AMENDMENT OF SOLICITATION/MODIFICATION OF CONTRACT				1. CONTRACT ID CODE	PAGE OF PAGES
2. AMENDMENT/MODIFICATION NO. 0001		3. EFFECTIVE DATE 07-Nov-2008	4. REQUISITION/PURCHASE REQ. NO.		1 17

14. DESCRIPTION OF AMENDMENT/MODIFICATION (Organized by UCF section headings, including solicitation/contract subject matter where feasible.)					
<p>ANA, Training Range Complex, Mazar-e-Sharif, Afghanistan</p> <p>Delete Section 00010 - Proposal Schedule and Section 01010 - Scope of Work in their entirety and replace with the attached Section 00010 - Proposal Schedule and Section 01010 - Scope of Work. The point of contact for this effort is Marston Y. Guese at e-mail address marston.y.guese@usace.army.mil</p> <p>THE REVISED COST/PRICE PROPOSAL DUE DATE REMAINS THE SAME AT 1700 HR, 25 NOV 2008.</p> <p>PRE-PROPOSAL SITE VISIT IS SCHEDULE ON WEDNESDAY, 12 NOV 2008 AT 10:00 AM. POINT OF CONTACT IS MS. KRUEGER AT MOBILE NUMBER: 079-686-7954 AND EMAIL: ulrike.krueger@usace.army.mil</p> <p>ALL OTHER TERMS AND CONDITIONS REMAIN UNCHANGED.</p> <p>Except as provided herein, all terms and conditions of the document referenced in Item 9A or 10A, as heretofore changed, remains unchanged and in full forc

MAP OF BATTLE CLEARED AREA IN BALKH PROVINCE DEHDADI DISTRICT USACE PROJECT TASK NO 671-38

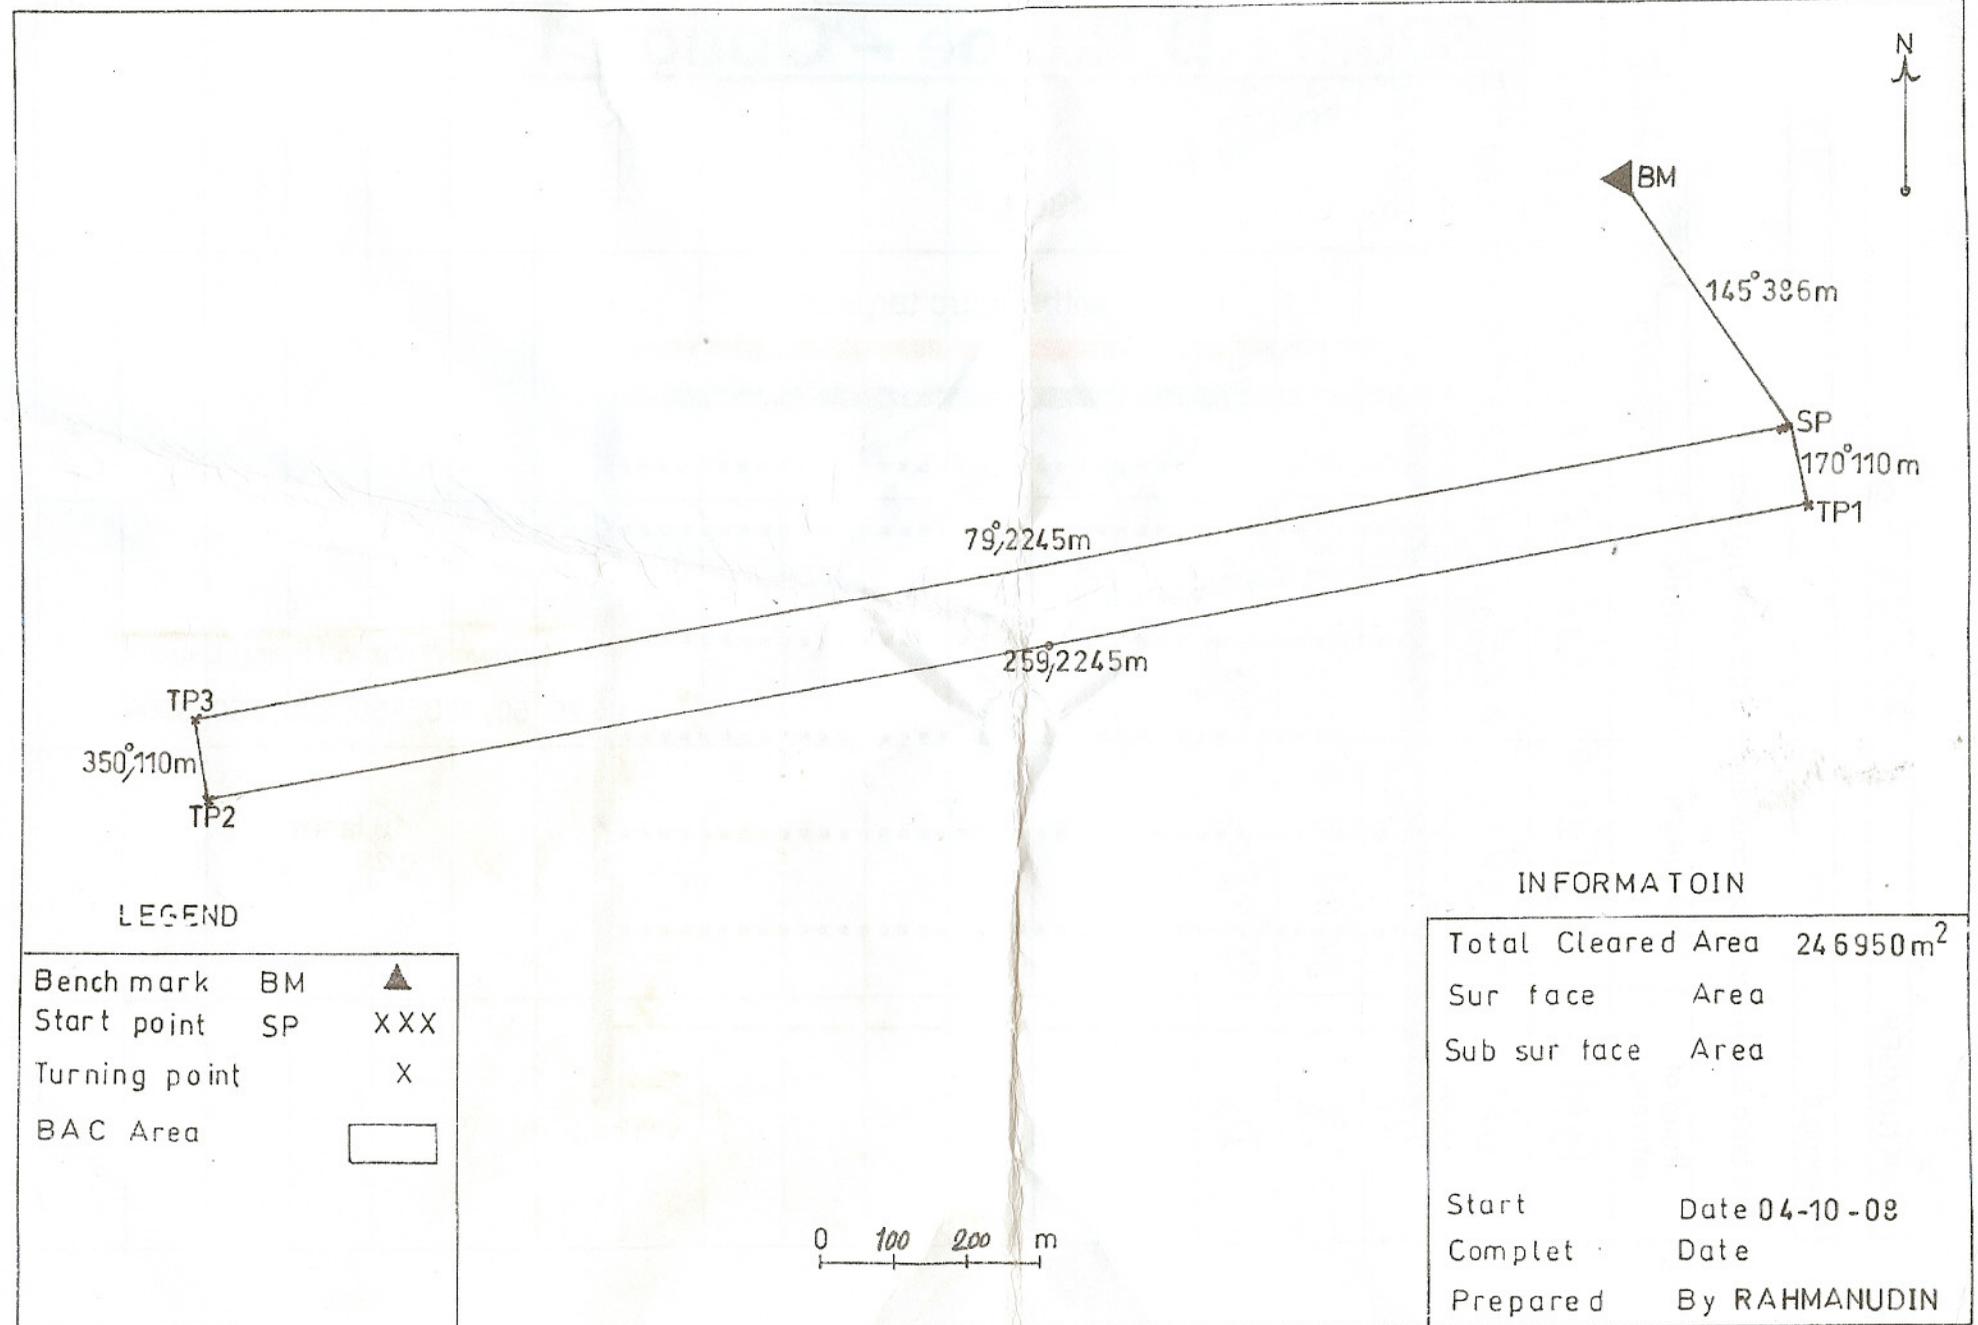
Appendix T- Range Clearance by Others (Revised with demined coordinates added)
